Date: October 8, 2024

Project Owner: SMD 1/Town of Superior

Project: SMD1 Anaerobic Zones Project

Purpose: To Clarify and Modify Plans, Contract Documents, and Special Provisions of the Project

3 DETAIL EQUIPMENT PAD NO SCALE

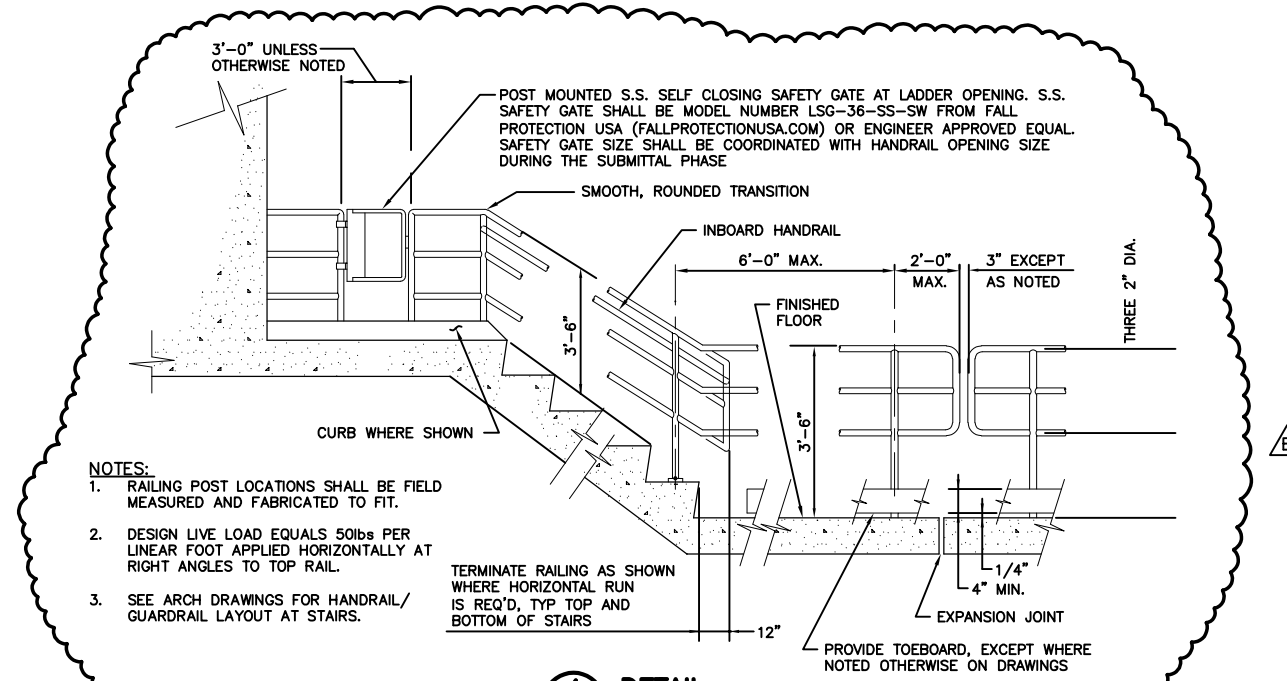
1. S-2 Standard Details: Equipment pad and typical guard/handrail provided.
2. 500-1: Town of Superior Standard Precast Concrete Manhole Detail
3. 600-1a and 600-2: Town of Superior Standard Storm Manhole Details

STANDARD PRECAST CONCRETE MANHOLE WITH CAST IN PLACE MANHOLE BASE

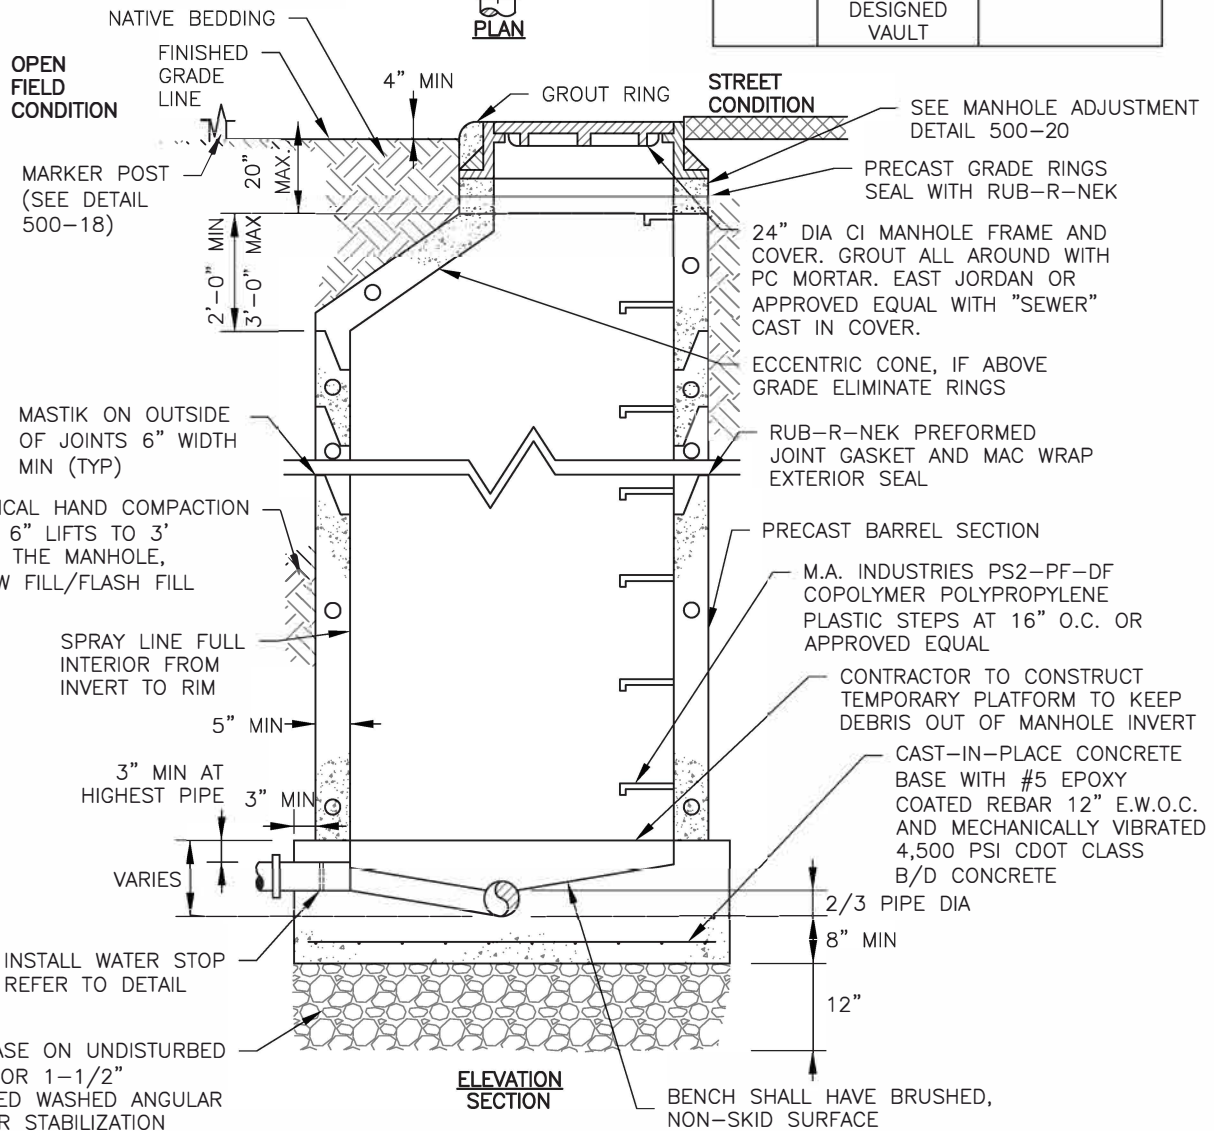
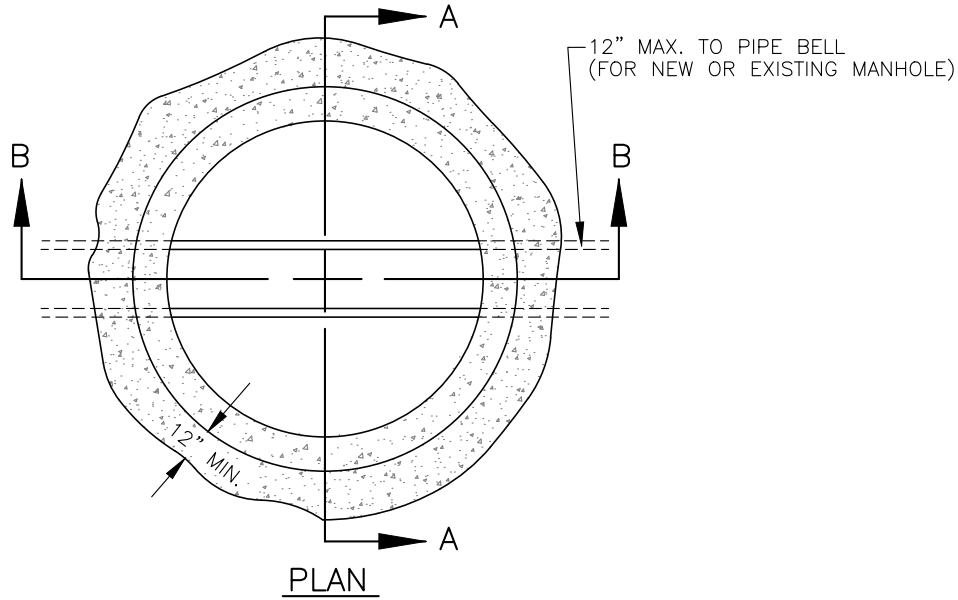
1. Please provide details for the new manholes identified on drawing C-2.

RESPONSE: *The new influent wastewater manhole and storm sewer manhole shall be in accordance with the Town of Superior Design Standards and Specifications. As such, this new influent wastewater manhole shall be 72" in lieu of the 60" called out on the plans. The storm sewer manhole shall be 60" in accordance with the Town Standards for a 24" storm sewer. The typical details are attached in this addendum. Additional requirements can be found on the Town of Superior Website:*
